14 October 2005  
Y0323-02.00257

**Subject: Workplan Addendum, Toxics Case RO0002586, 751-785 Seventh Street, Oakland, CA 94607, Former Francis Plating**

# PREVIOUS AND PROPOSED SAMPLE LOCATIONS

Figure 1

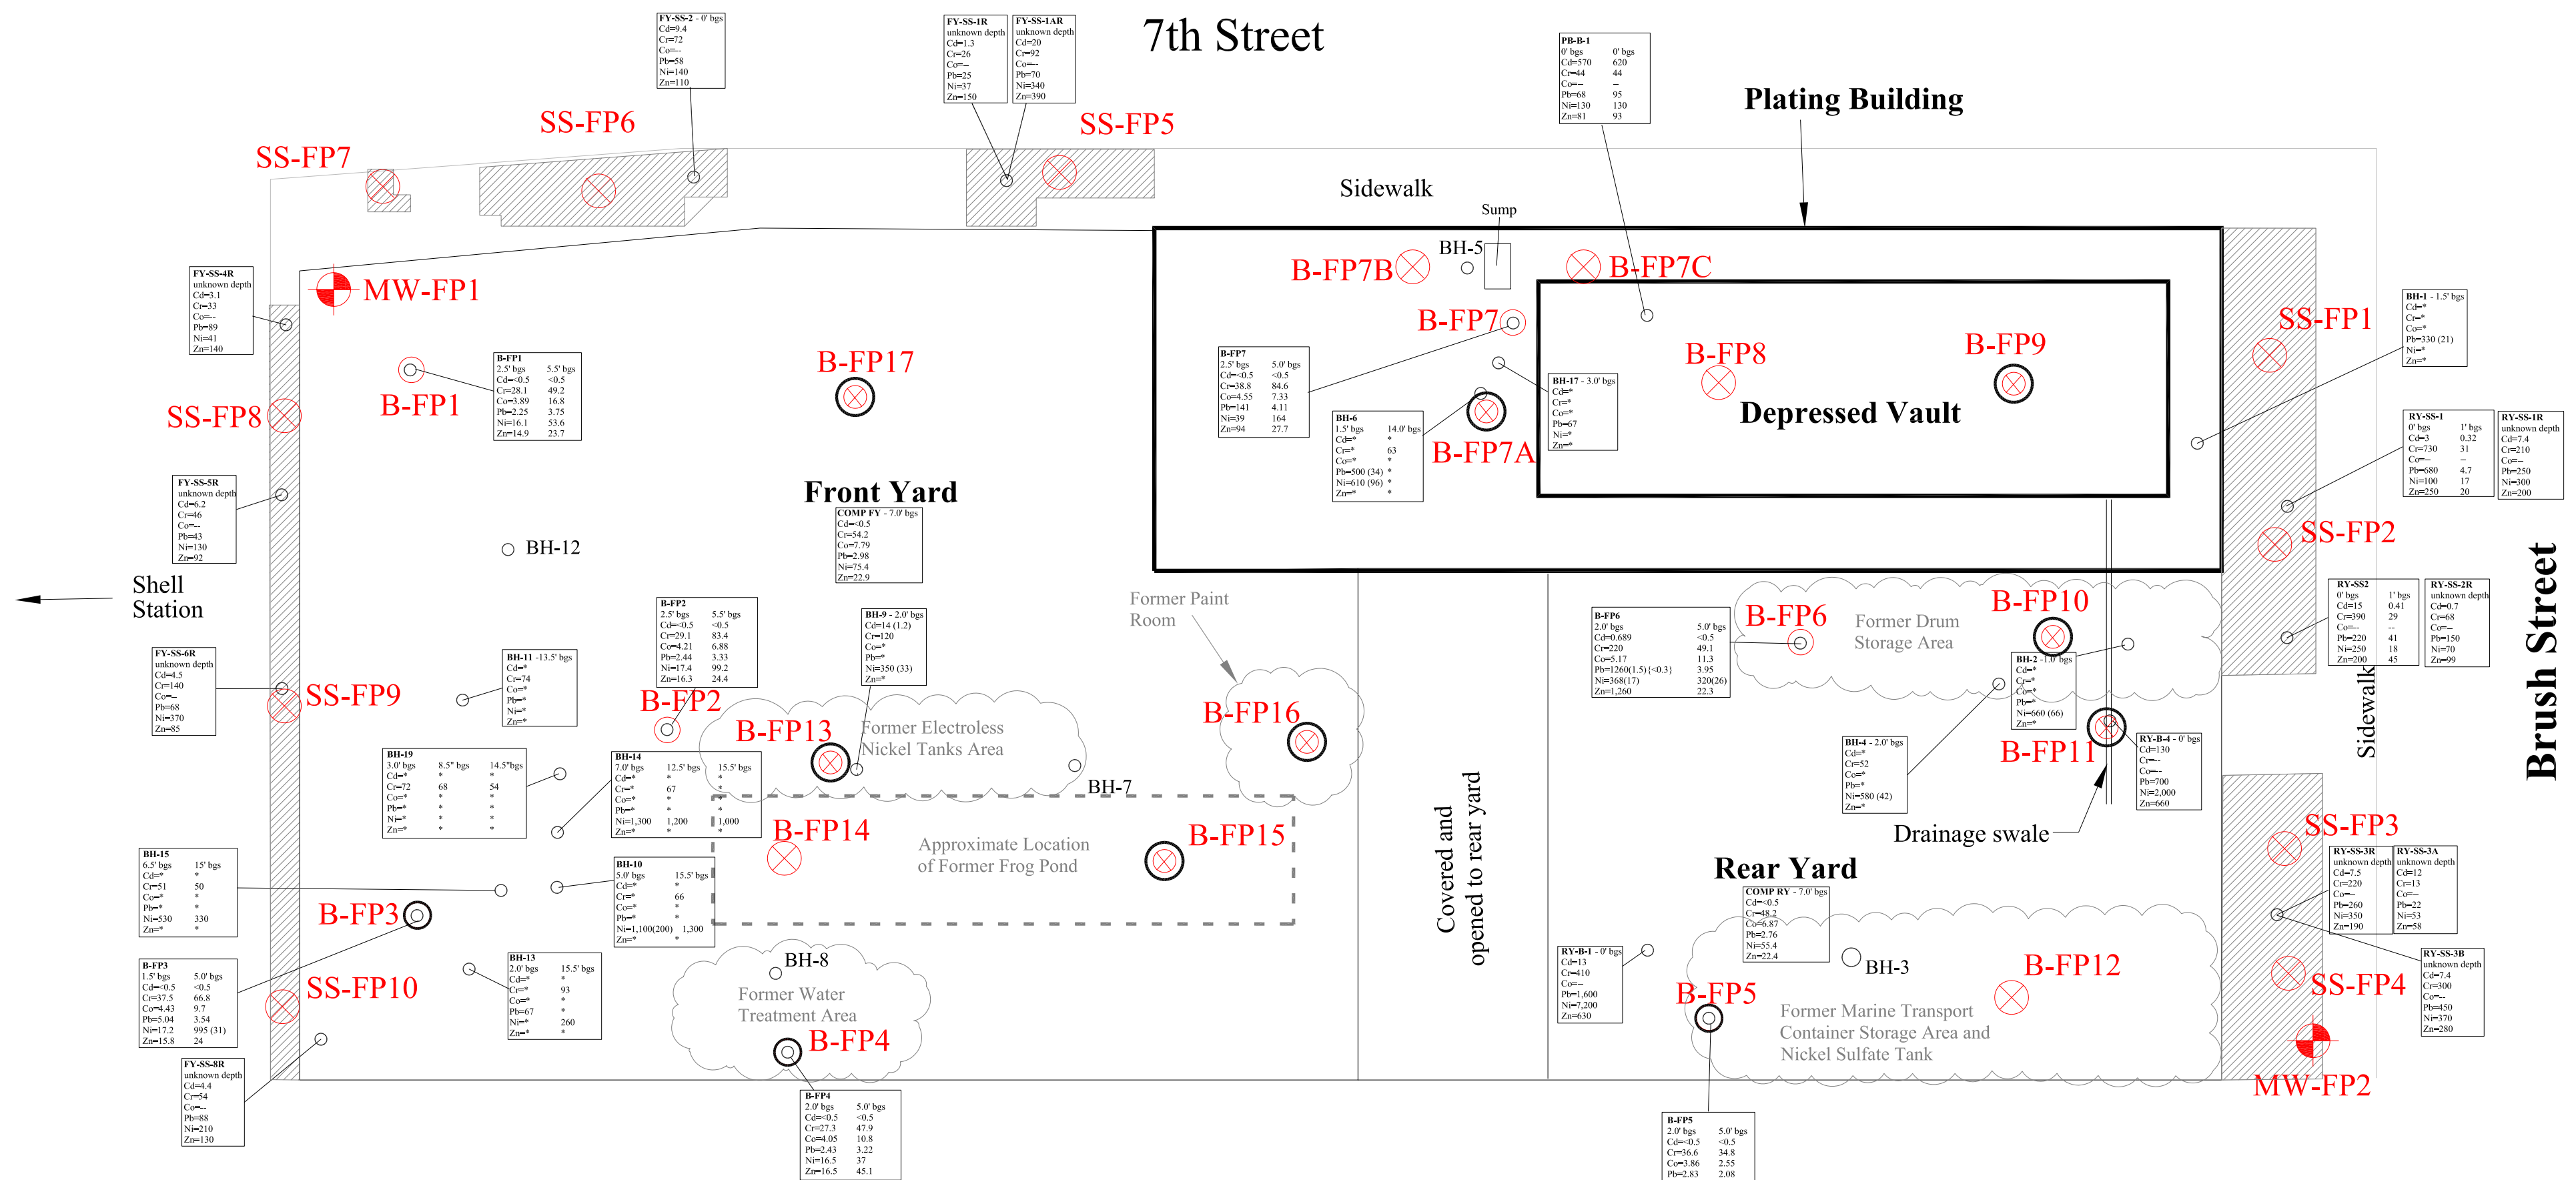
- One additional boring will be installed in the location between two trailers, formerly located at the site (location "SED"). This boring will be identified as "B-FP17" (Figure 1). Two soil samples will be collected from this boring at one and three to four feet below ground surface, similar to the sample depths proposed for the borings proposed in the 14 September 2005 Workplan.

- Additional grab groundwater samples will be collected near former source areas. The additional grab groundwater samples will be collected by advancing proposed boreholes to about five feet below the identified groundwater surface; a temporary, pre-packed, one-inch PVC well casing will be installed to facilitate groundwater sample collection. The additional groundwater samples will be collected from six locations on-site, as listed in the table below. The samples will be analyzed for VOCs. The samples will be handled in a manner similar to that described in the 14 September 2005 Workplan.
